BRIEFING SUMMARY SHEET

DEVELOPMENT ASSESSMENT CASE NUMBER: CD-2018-0008 – Austin Green

Presentation of a Project Assessment Report for the Austin Green Planned Unit Development, located at 11600-12337 Harold Green Road, within the Colorado River Watershed and the Elm Creek Watershed.

MASTER REVIEW REPORT

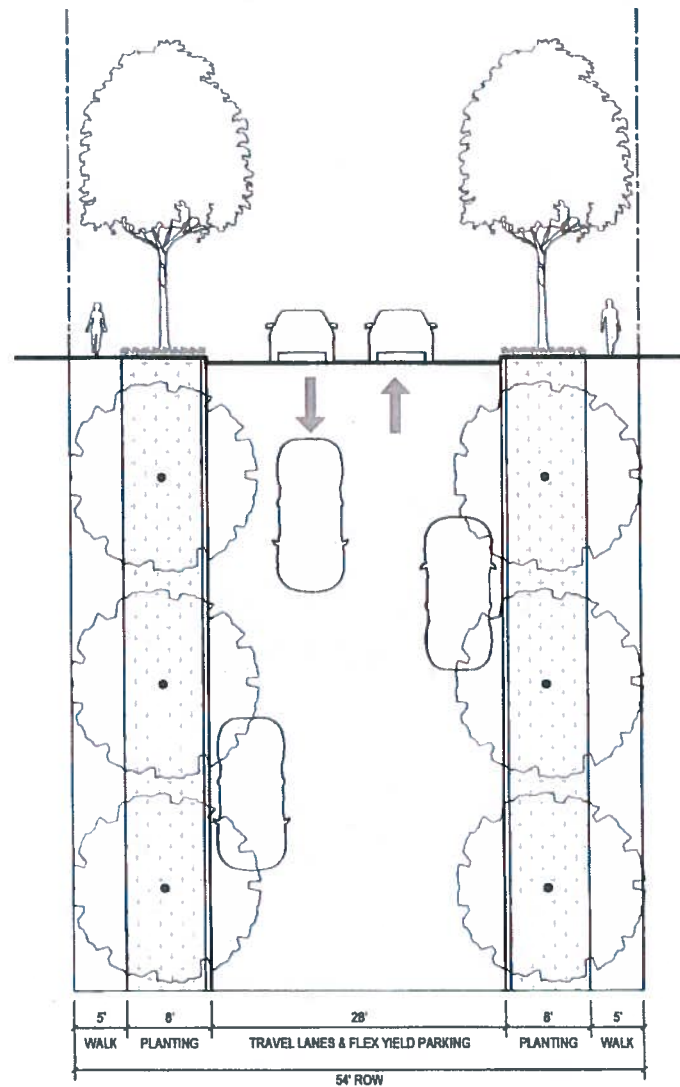
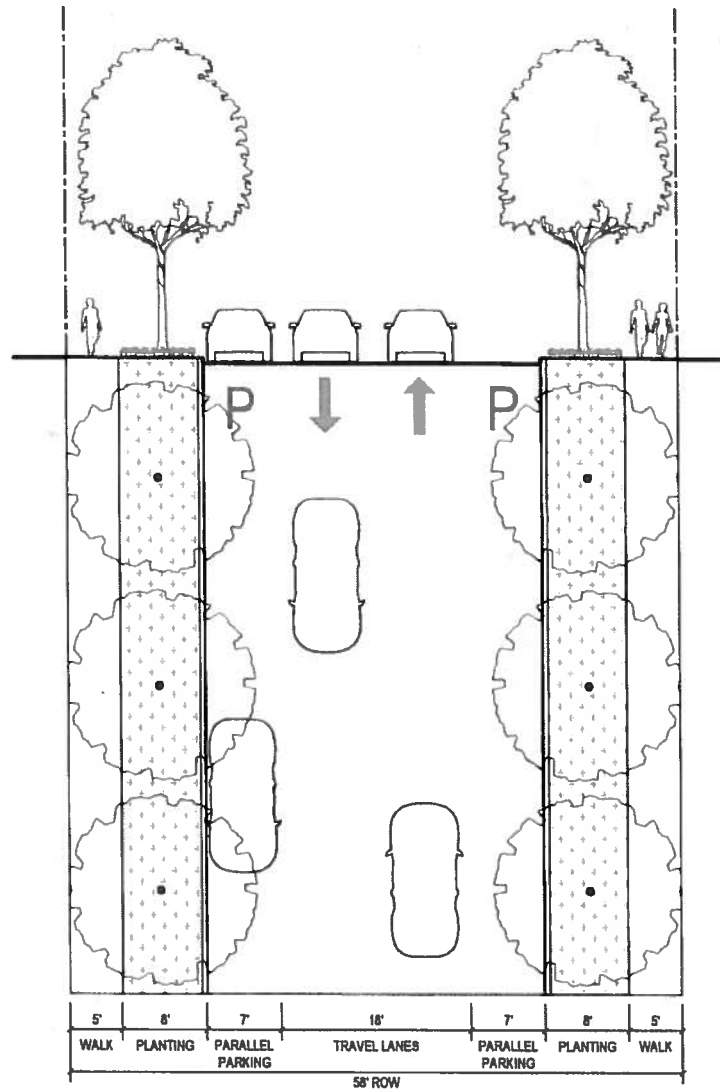
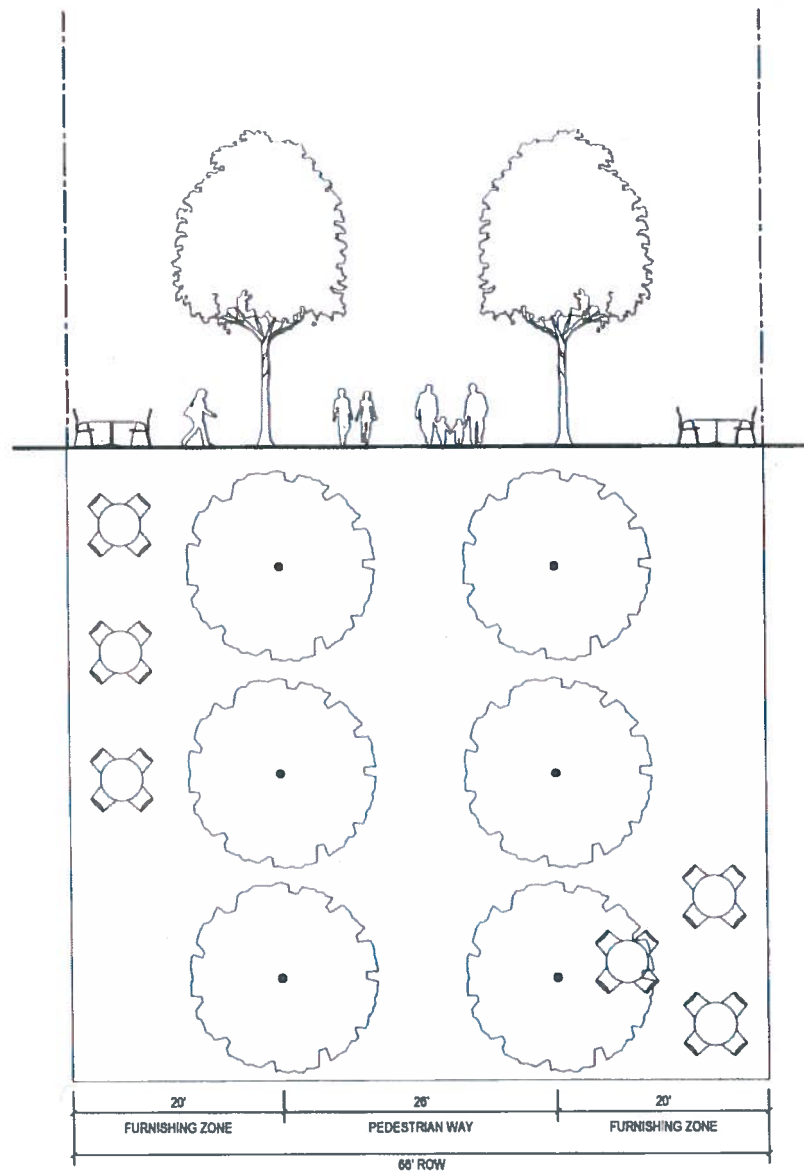
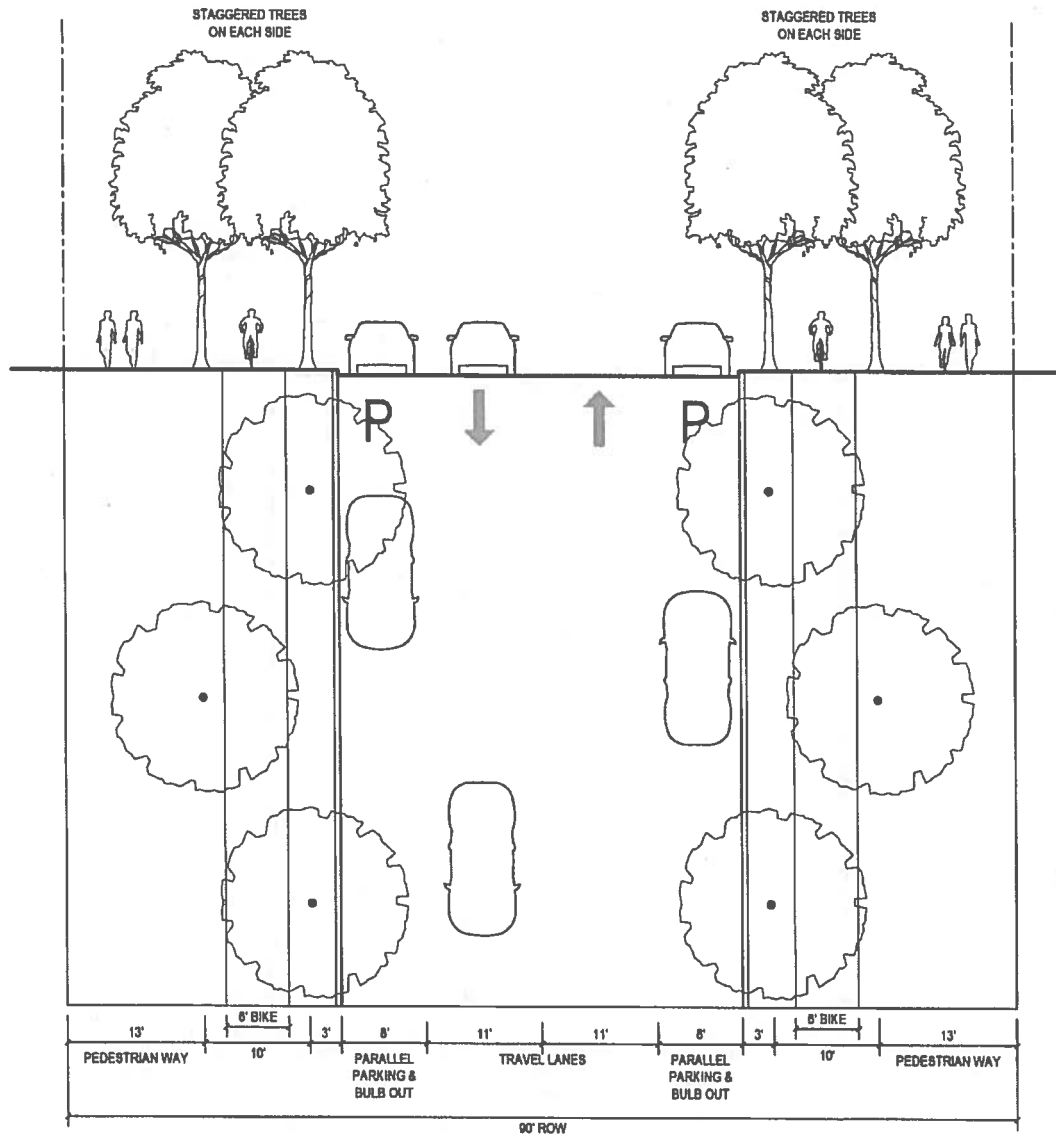
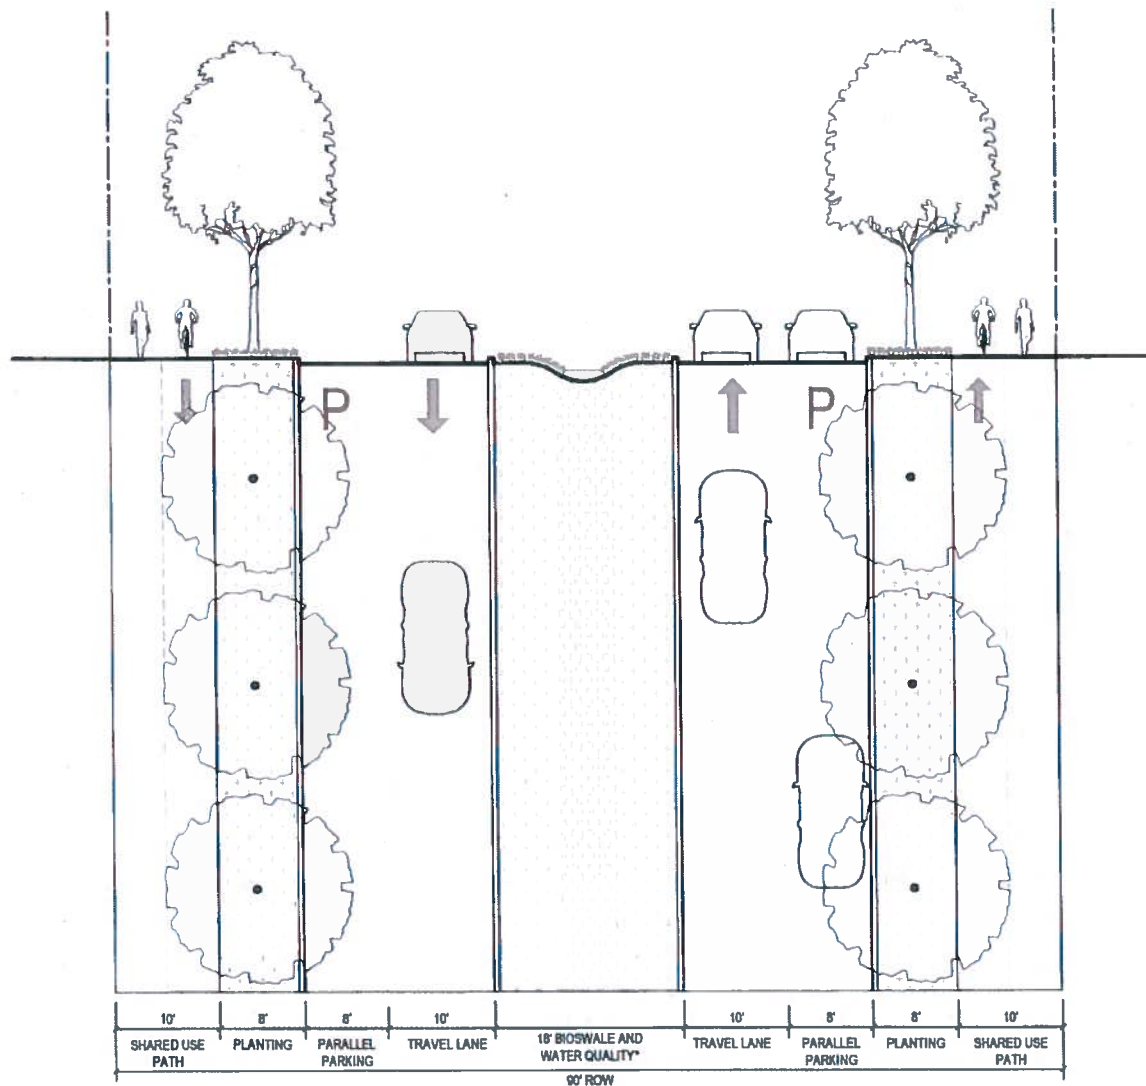
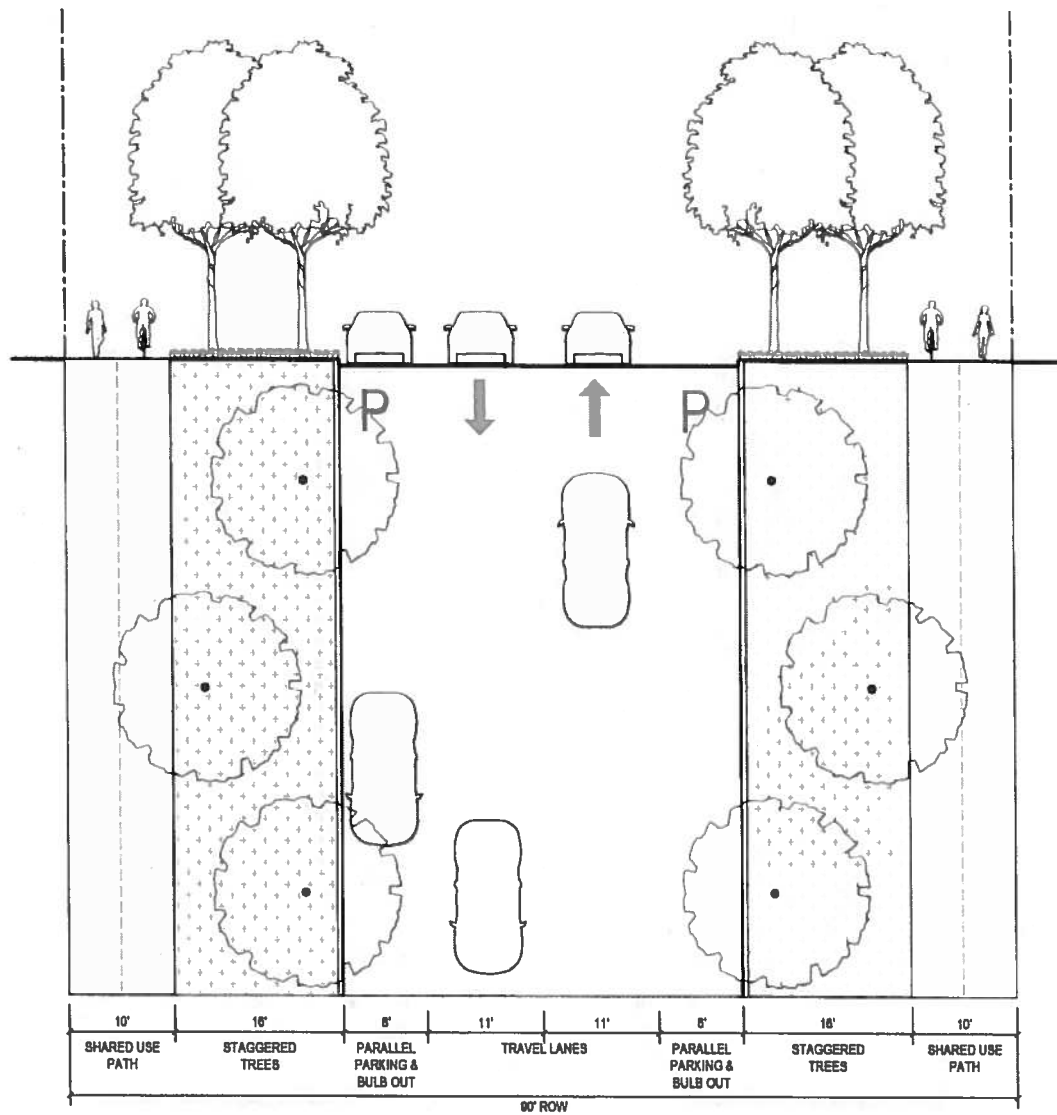
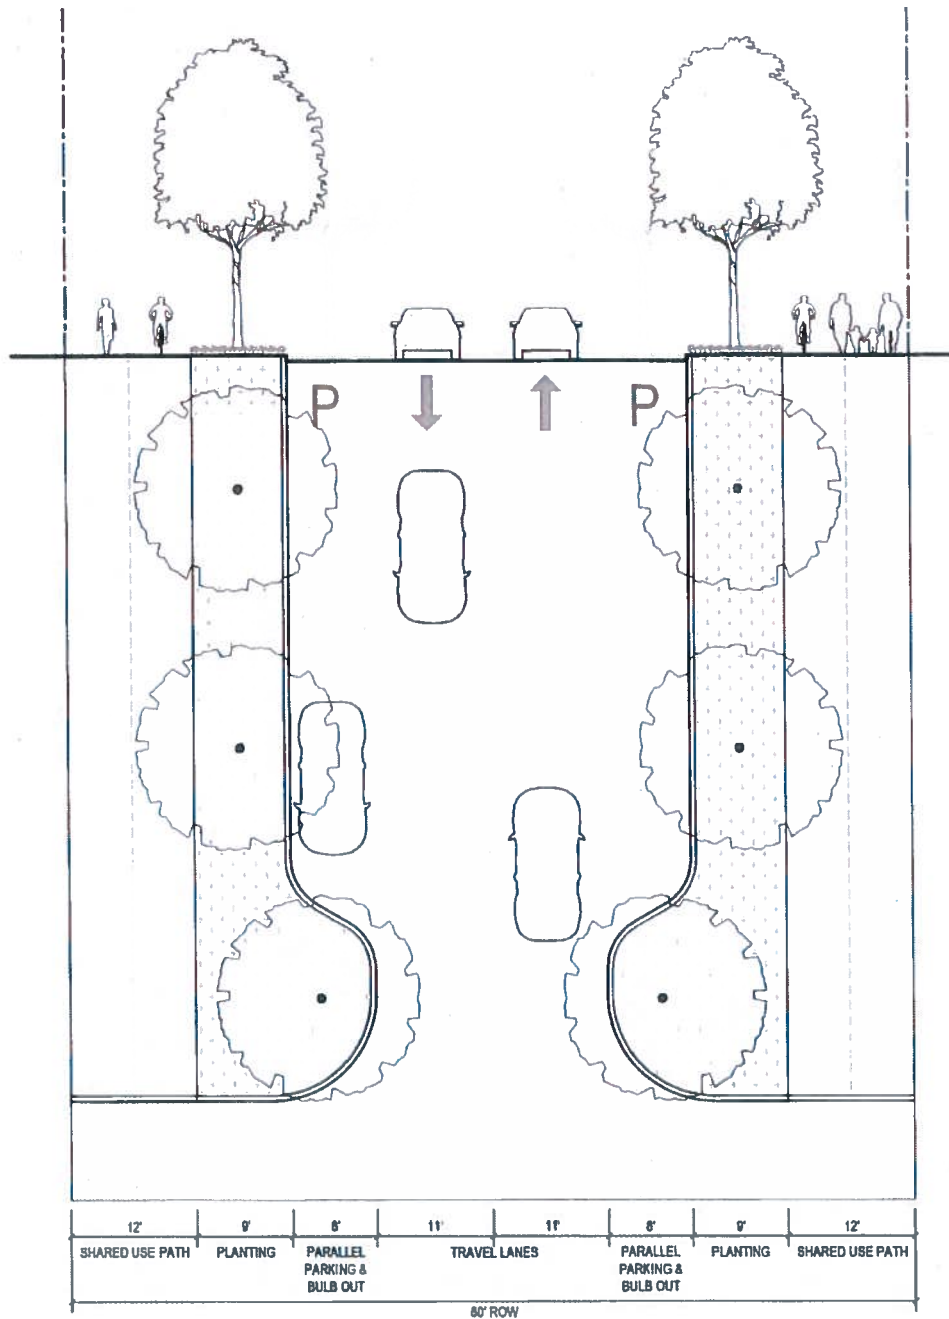
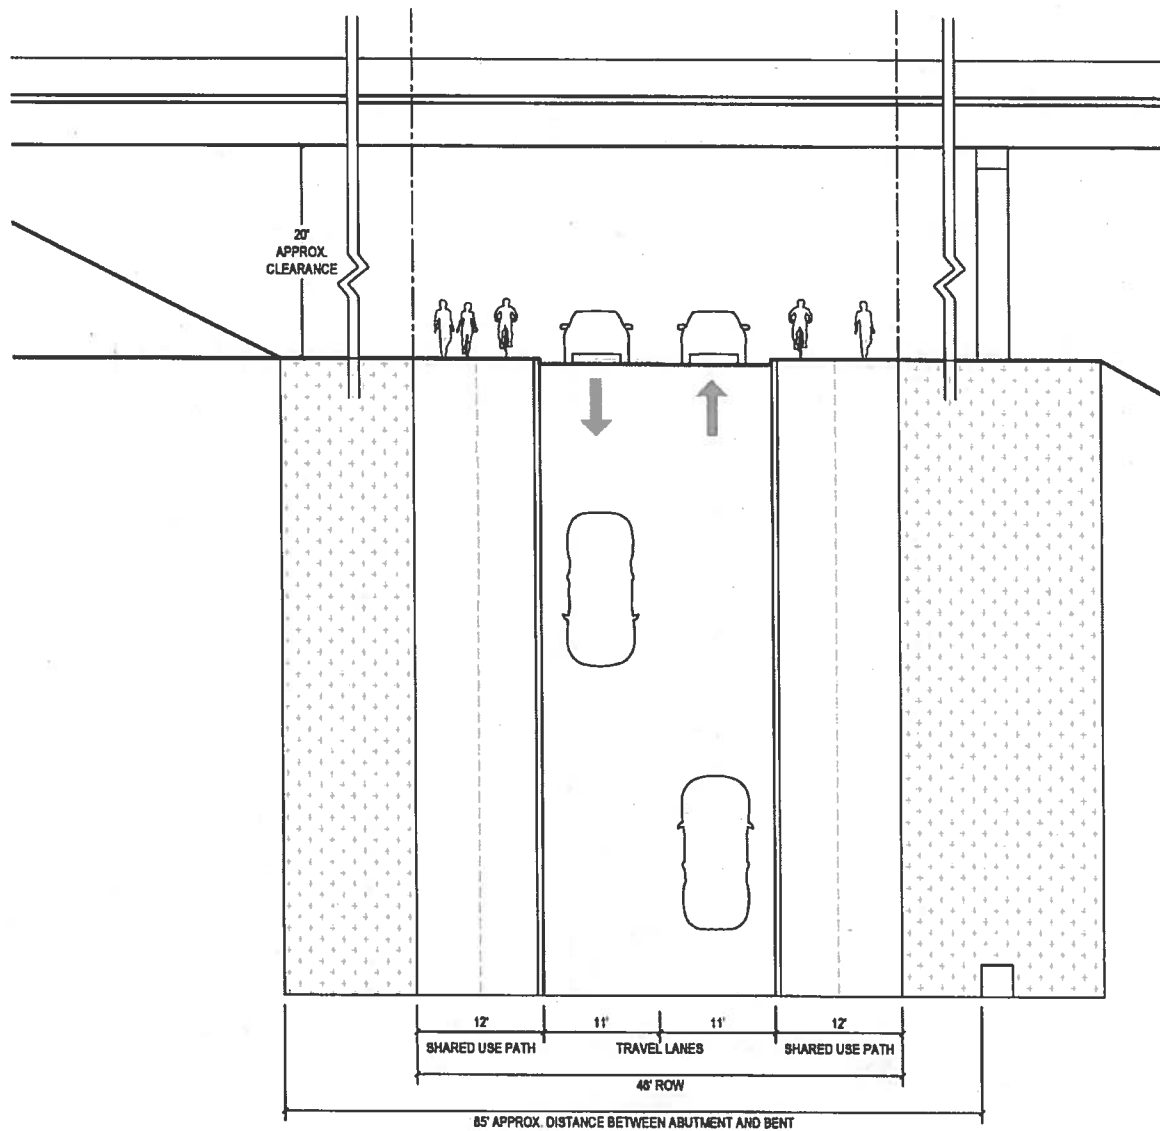
1. Please schedule a meeting with this reviewer and the Fire Marshal. Many of the proposed street sections do not comply with the Fire Code for access and/or operational area. Only the Fire Marshal has the authority to allow modification to the adopted Fire Code. Private roads shall be minimum of 25 feet wide void of parked vehicles. One way private roads providing fire access shall be a minimum 15 feet wide void of parked vehicles. Unless adjacent to buildings, the private road shall be a minimum 25 feet wide void of parked vehicles, landscaping and landscape furniture.
2. Fire protection is a Tier One activity per the City's PUD ordinance. Any deviation from the adopted Fire Code must be explicitly written in the development's PUD zoning ordinance or related exhibits.
3. Please identify any industrial activities within 1000 feet of the project area with zoning plan.
